SERIAL: BSEP 03-0035
TSC-2002-06

BRUNSWICK STEAM ELECTRIC PLANT, UNIT NOS. 1 AND 2
DOCKET NOS. 50-325 AND 50-324/LICENSE NOS. DPR-71 AND DPR-62
RESPONSE TO REQUEST FOR ADDITIONAL INFORMATION REGARDING
TECHNICAL SPECIFICATION 3.1.7, "STANDBY LIQUID CONTROL SYSTEM"
SODIUM PENTABORATE SOLUTION REQUIREMENTS
(NRC TAC NOS. MB5680 AND MB5681)

Response to Request for Additional Information

Figure 3.1.7-1 (page 1 of 1)
Sodium Pentaborate Solution Volume
Versus Concentration Requirements

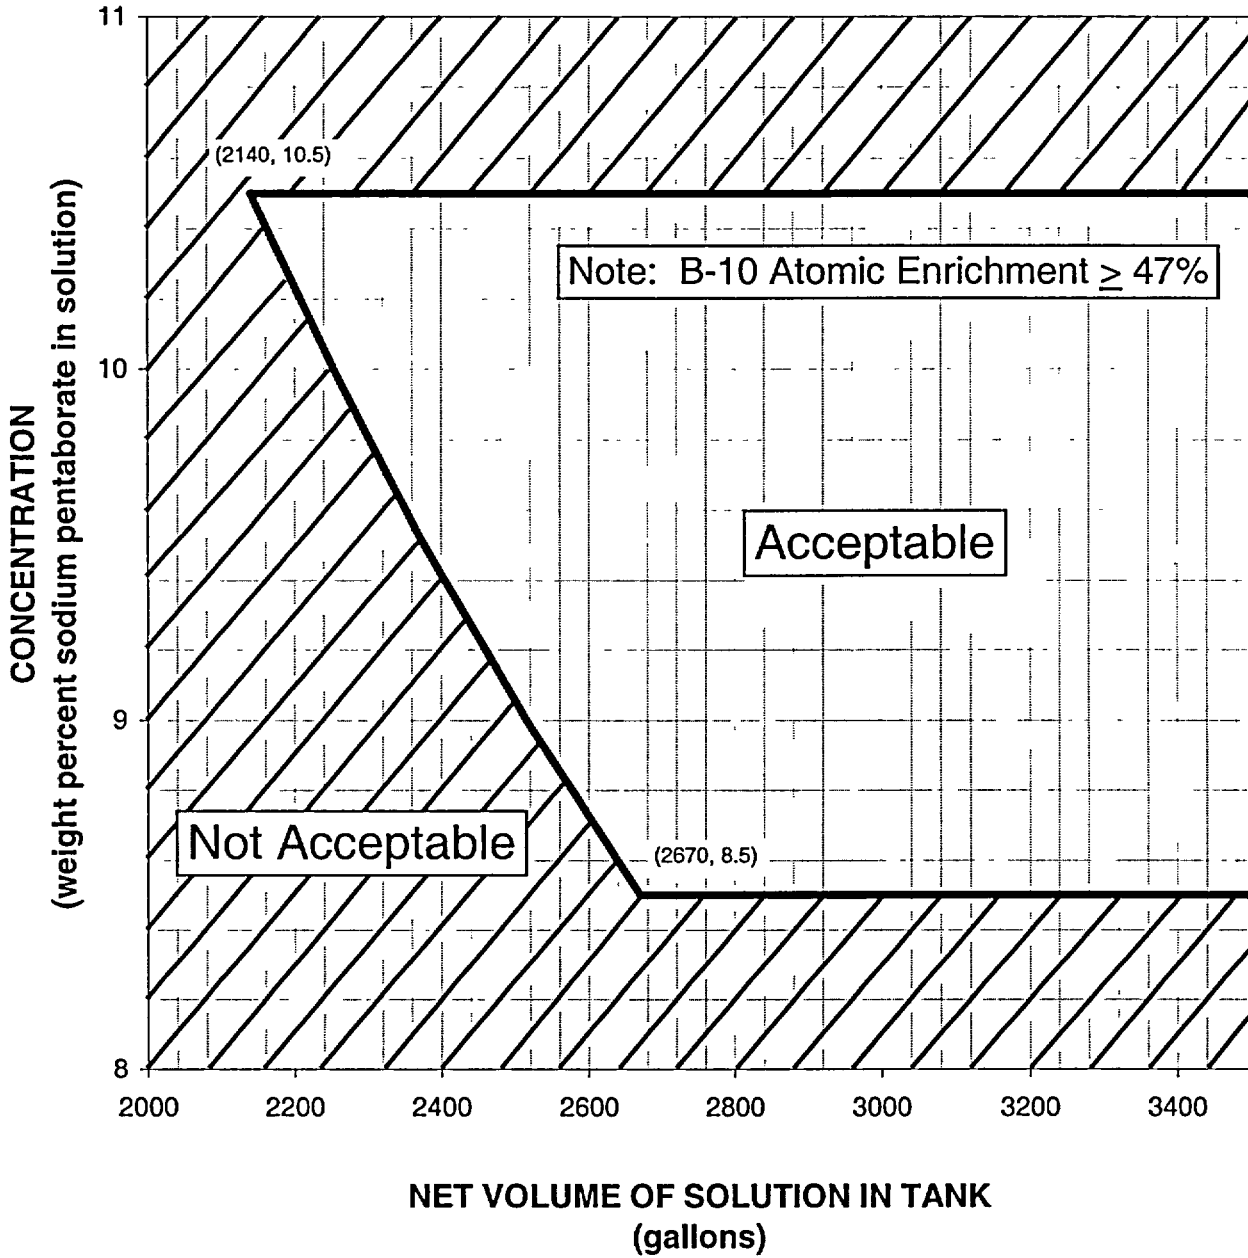
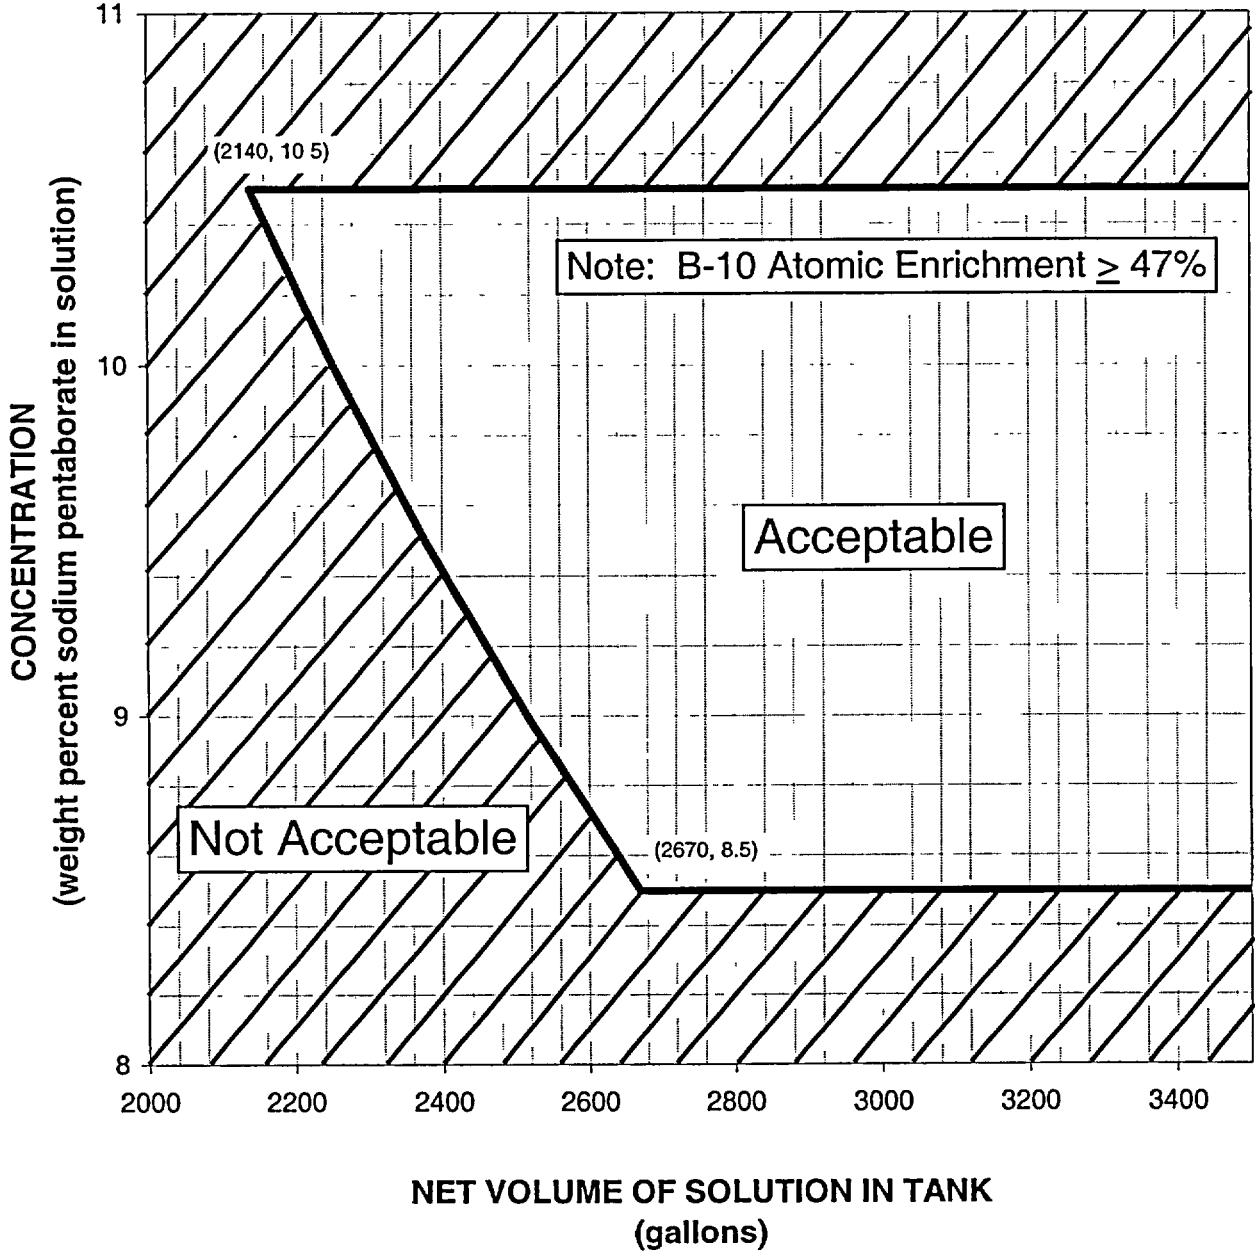
Enclosure 2 contains updated typed technical specification pages associated with this amendment request. An editorial change has been made to the label of the x-axis in Figure 3.1.7-1, "Sodium Pentaborate Solution Volume Versus Concentration Requirements," for each unit. The figure submitted in BSEP 02-0124 labeled the x-axis as "Gross Volume of Solution In Tank." The enclosed figures correctly label the x-axis as "Net Volume of Solution In Tank." Progress Energy Carolinas, Inc. has determined that this correction does not affect the bases for concluding that the proposed amendments do not involve a Significant Hazards Consideration. As such, the 10 CFR 50.92 Evaluation, provided in the July 24, 2002, submittal and published in the Federal Register (i.e., 67 FR 53984, dated August 20, 2002) remains valid.

Figure 3.1.7-2 (page 1 of 1)
Sodium Pentaborate Solution Temperature
Versus Concentration Requirements

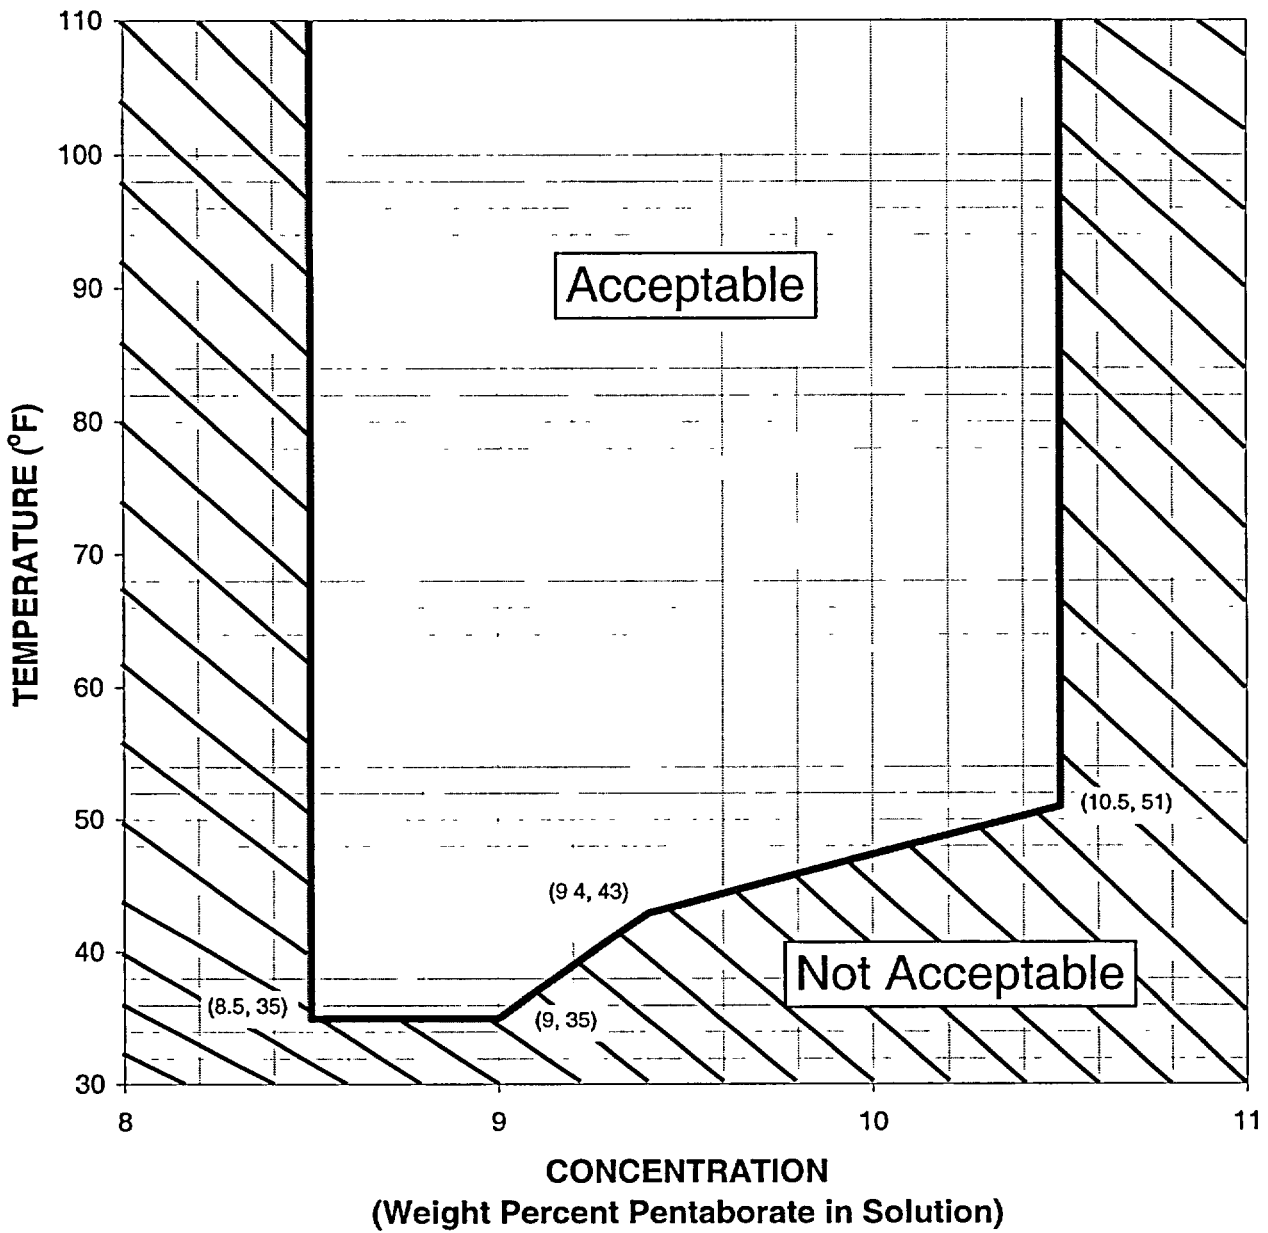
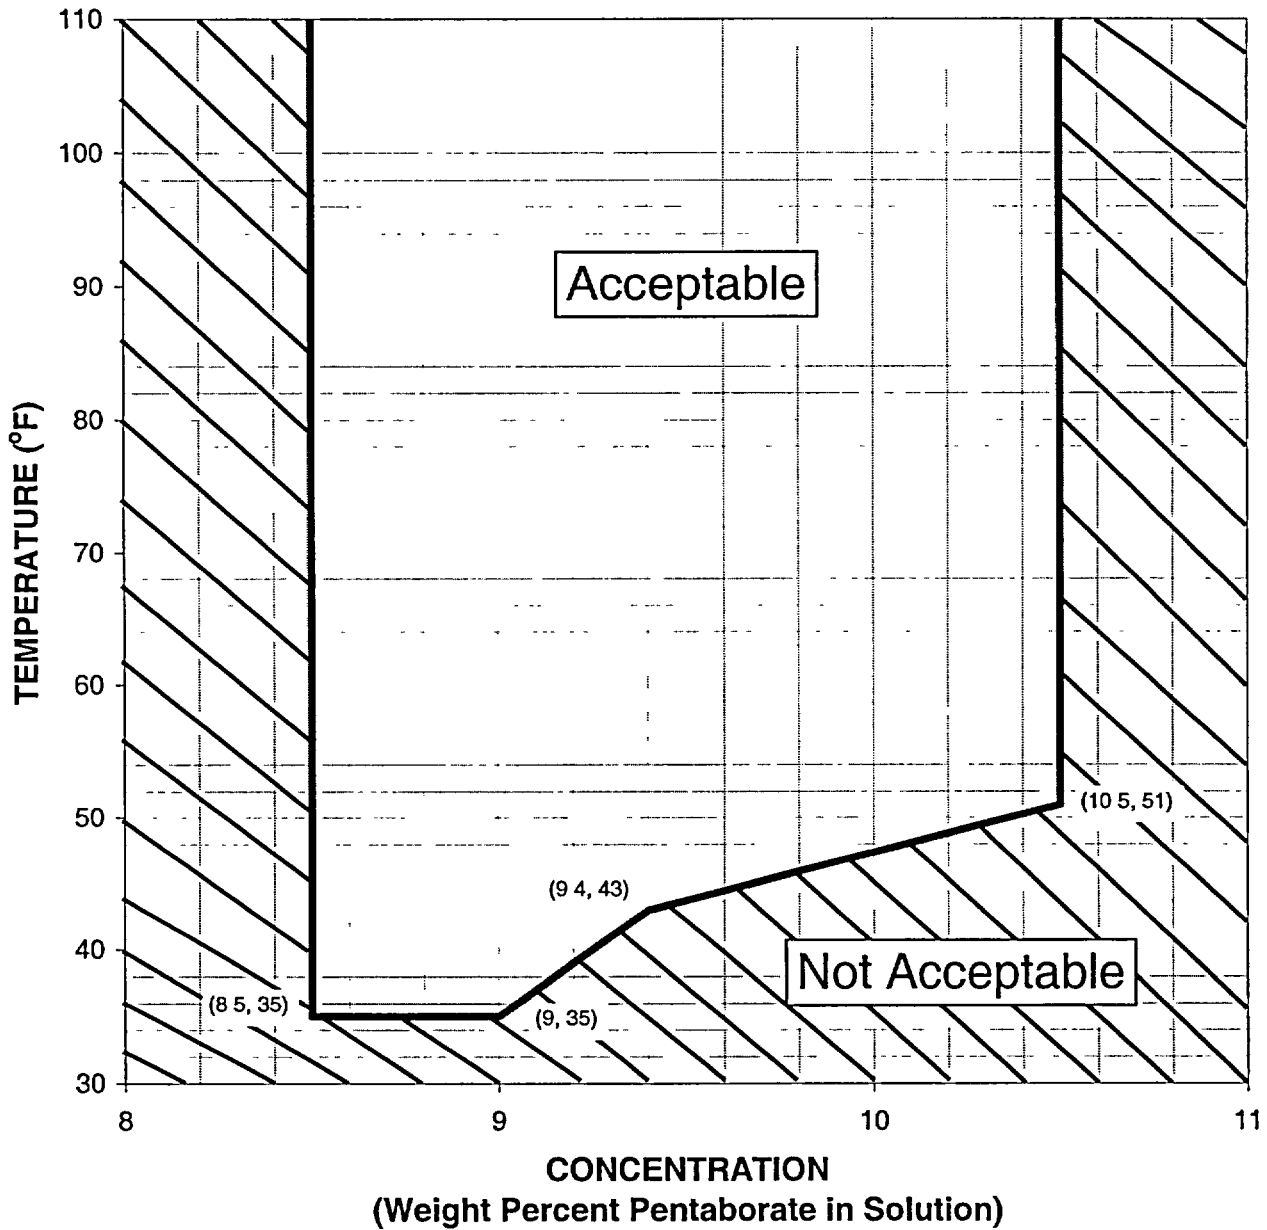
State if other changes (e.g. configuration, SLC relief valve upgrade) would be performed on the SLC system? The revised Figure 3.1.7-2 indicates the minimum required boron solution temperature changes from approximately 65 F to 35 F. Therefore, state if CP&L plans to remove the heat tracing?

1. The SLC system piping heat tracing is being removed as a result of the planned modification. SLC system piping heat tracing was installed to allow higher boron solution concentrations to be used without any crystallization problems. However, maintaining heat trace for the duration of the winter months requires a significant effort. It also relies on the active protection provided by thermostats and the passive protection provided by insulated pipes. Eliminating reliance on piping heat trace is a significant reliability improvement for the SLC system.

The local thermocouples used for piping temperature verifications will not be removed and the existing Technical Specification surveillances associated with piping temperature verifications are maintained. The temperature requirements will be based on the actual solution chemical concentration and will range from 35 °F to 51 °F. Although building temperatures below 57 °F are not expected, BSEP has administrative provisions for placing temporary area heaters in service if needed. Also, tank concentration can be easily reduced by adding water to the tank. These provisions ensure that the SLC system can be maintained operable even if building temperatures drop lower than expected.
